**TOWN OF ARLINGTON, MASSACHUSETTS
ADVANCED METERING INFRASTRUCTURE AND METER DATA MANAGEMENT
CONTRACT NO. 18-38**

ADDENDUM NO. 1

To be considered as part of the request for proposals for Contract 18-38.

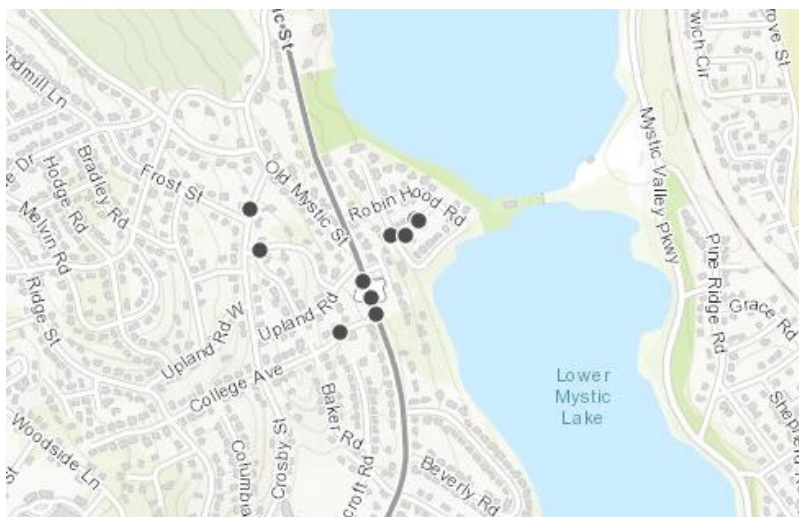
Question: Is the pilot program just requiring the installation of 1 data collection unit along the 40 endpoints?

Answer: The RFP does not specify the number of data collection units. Bidders may assume that the pilot will be in a geographically centered area. A noteworthy problem area likely to be selected is the Mystic Lake area, as shown in the figure to the left.
